Document Review Comment Sheet

PEB Ref. No : TB2-PEB-SDC-M1B-TVI-02734

DRAWING TITLE									
HP FEEDWATER HEATER #6 11LAD10AC006/21LAD10AC006 DESUPERHEATING SUB ASSEMBLY									
VENDOR NAME			FUNCTION	NAME	SIGN	DATE	SHEET		
			DRWN	S.W.E.		24 FEB.2014	4/19		
			CHKD	H.K.LEE		24 FEB.2014			
			APPD	J.C.YOON		24 FEB.2014			
			APPD	S.S.KIM		24 FEB.2014

FIG. UG-118 FORM OF STAMPING

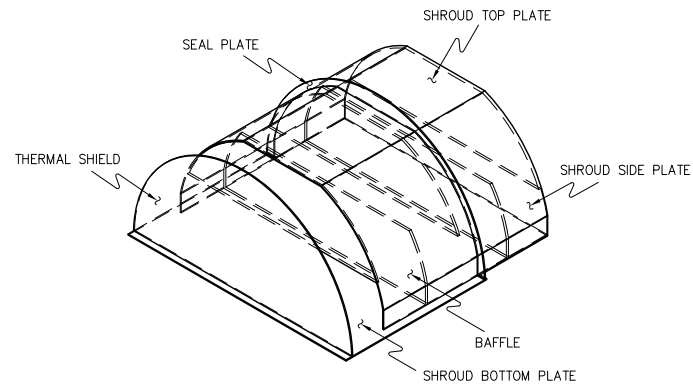
2	Please note that: Nameplates shall be in English with a minimum letter size of 6.4 mm.		ASME 'U'stamp project letter size was min 4mm.(UG-108). But we will used letter size 7mm.
